PUBLIC INTEREST REVIEW FOR GROUNDWATER APPLICATIONS

SUBJECT: Application G- 18012 Supersedes review of n/a
Date of Review(s)

A. GENERAL INFORMATION: Applicant's Name: Ivan Barsukoff County: Clackamas

A1. Applicant(s) seek(s) 0.11 cfs from 1 well(s) in the Willamette Basin,
Pudding River subbasin Quad Map: Yoder

Prop 9999 and Rock Creek

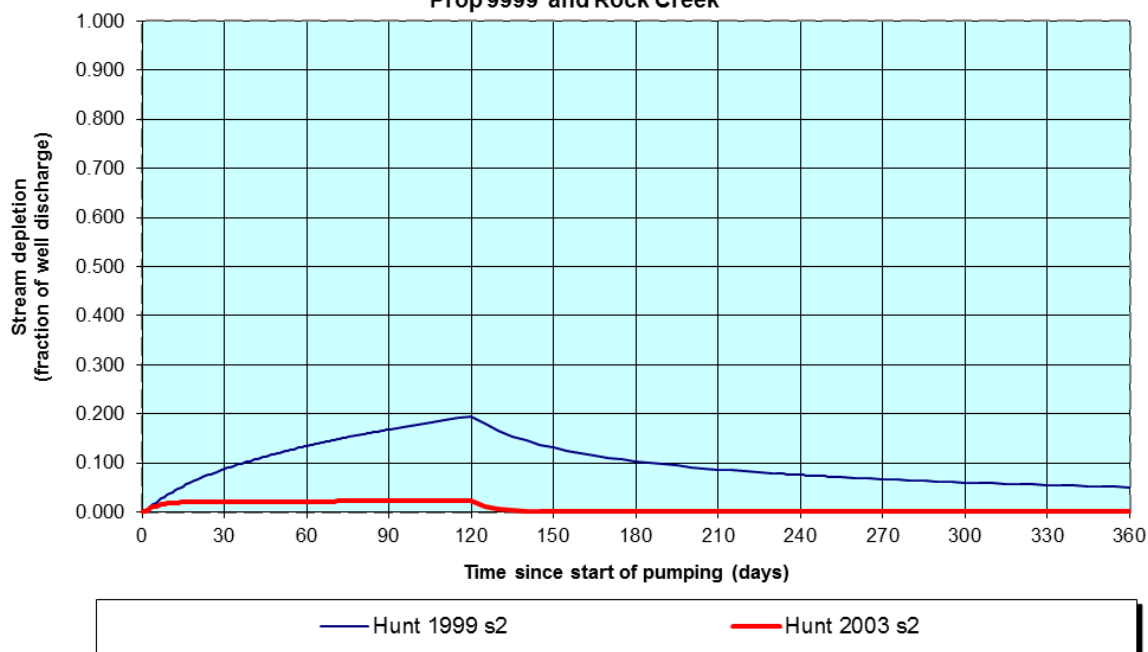
Comments: Stream depletion estimates using Hunt (2003) indicate interference at 30 days will be much less than 25% of the well discharge. See attached stream depletion estimates.
